PLANNING AND ZONING COMMISSION

TO: PLANNING AND ZONING COMMISSION  
FROM: LORRINE QUIMIRO, PLANNING MANAGER  
SUBJECT: CASE FILE NO. 2020-39-P  
APPLICANT: Nakia Ventures II, LLC, Owner  
Maverick Engineering, PC, Consultant

REQUEST: Replat

PROPERTY INVOLVED: Lots 1, 2, 3, & 4, Block 1, Valley Apple Addition, Odessa, Ector County Texas. (South of the intersection of E. Loop 338 and E. 52nd St.)

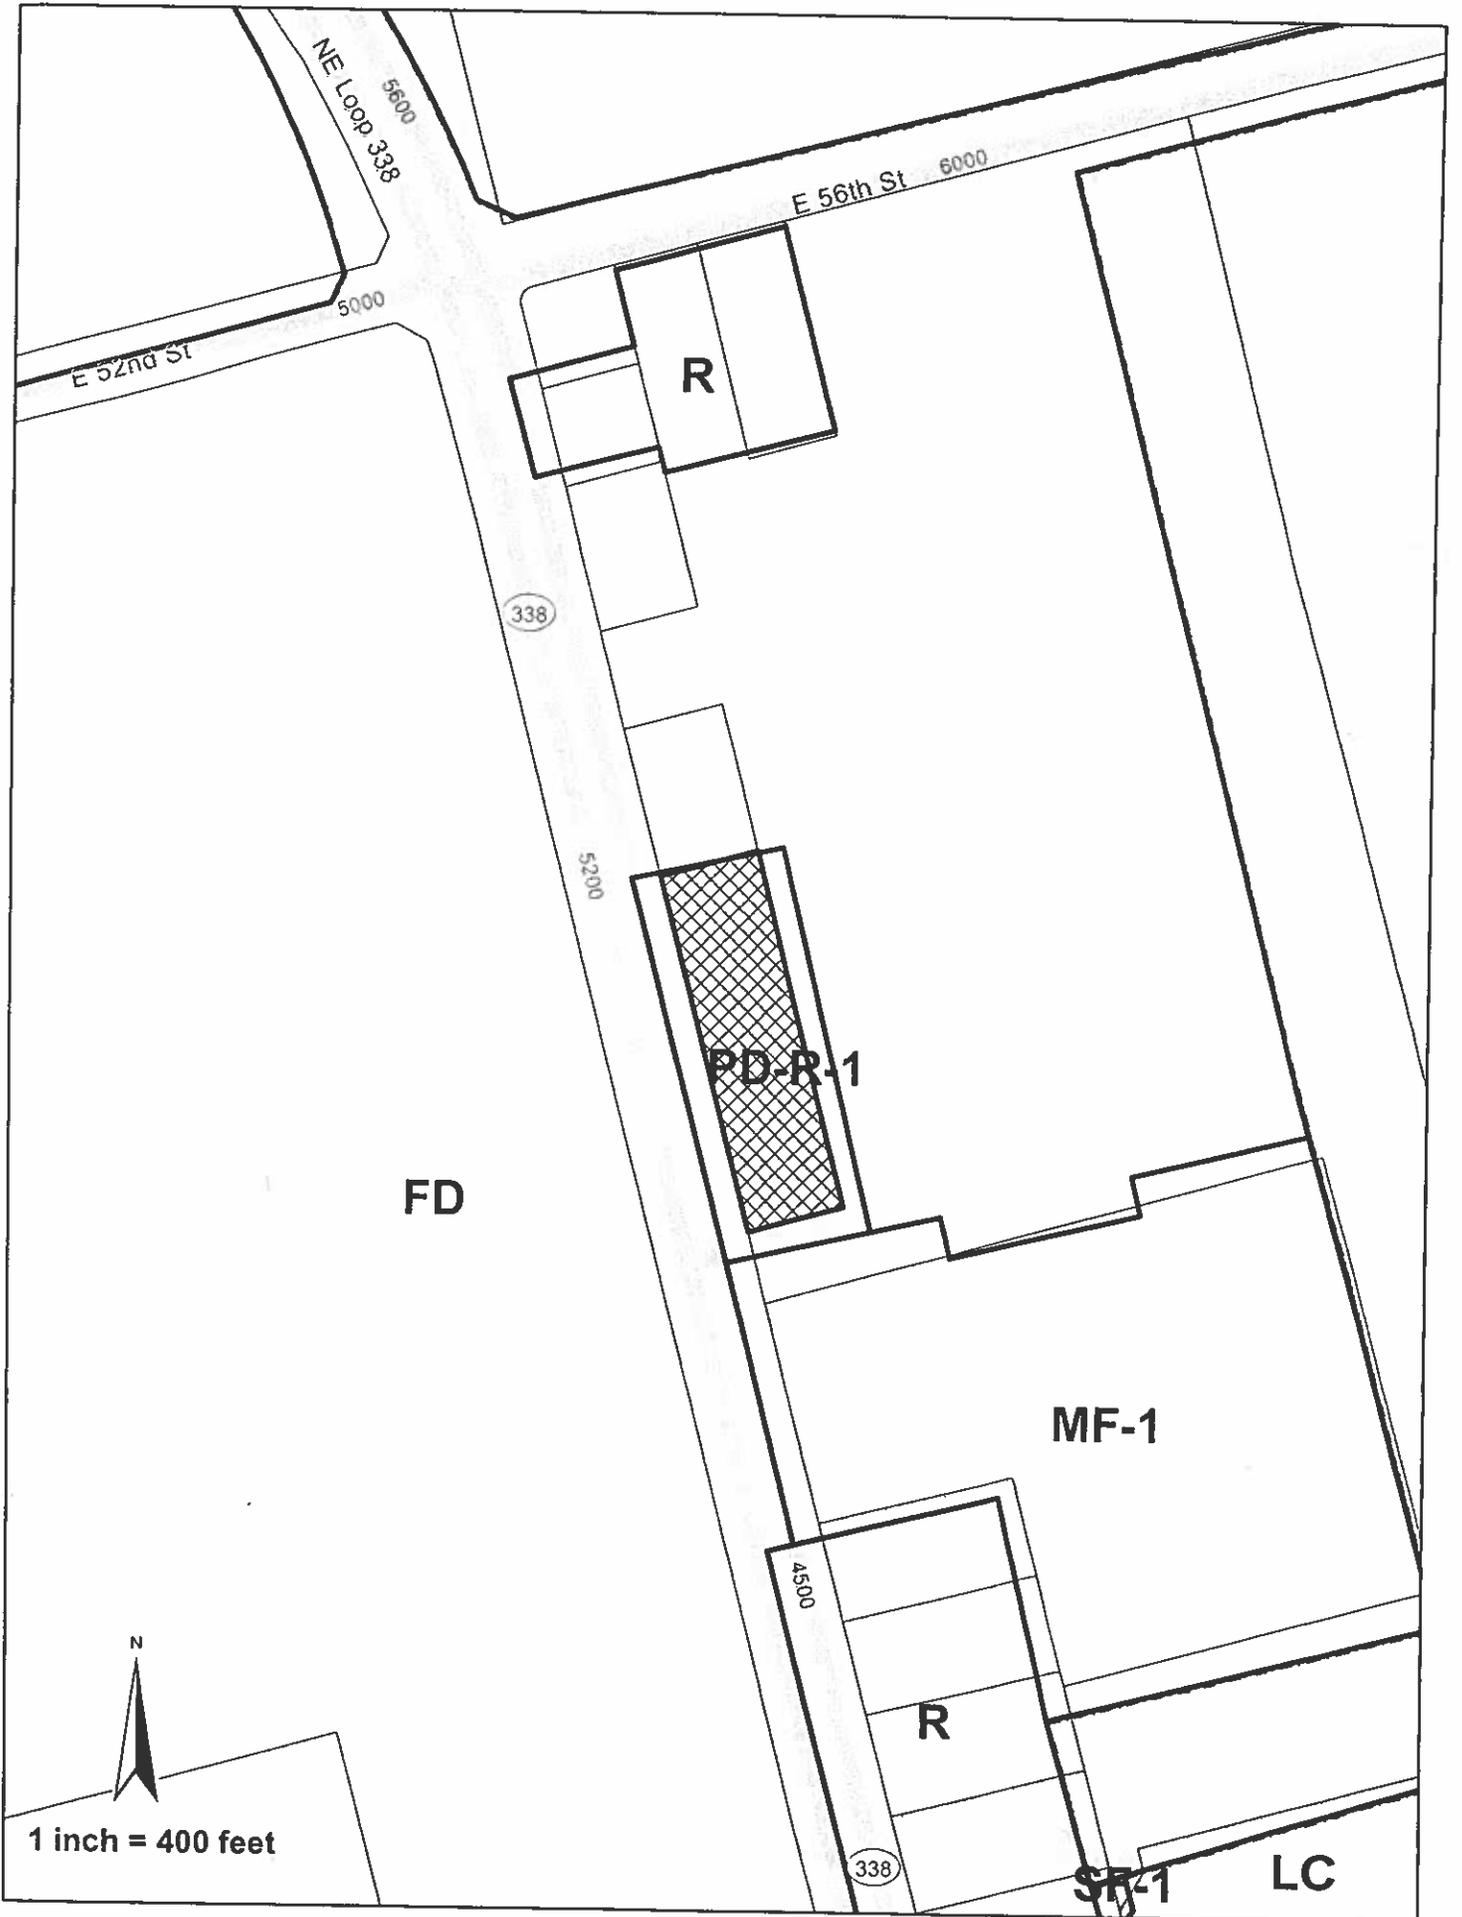
- Water is available, sewer needs to be extended to the north end of the property. No pro rata is due.
- Drainage report has been submitted. This tract is not in a special flood hazard area.
- Submit plans for sewer extension for review and acceptance.
- An Improvements Agreement will be required
- Any work in the right of way or easements will require a permit from the Engineering Division and must comply with current City Ordinances and policies

1. Show driveway access to E. Loop 338. Access should be in compliance with TXDOT Access Management Manual. (Public Works)
2. A Blanket Refuse Collection Easement Agreement will be required. (Public Works)
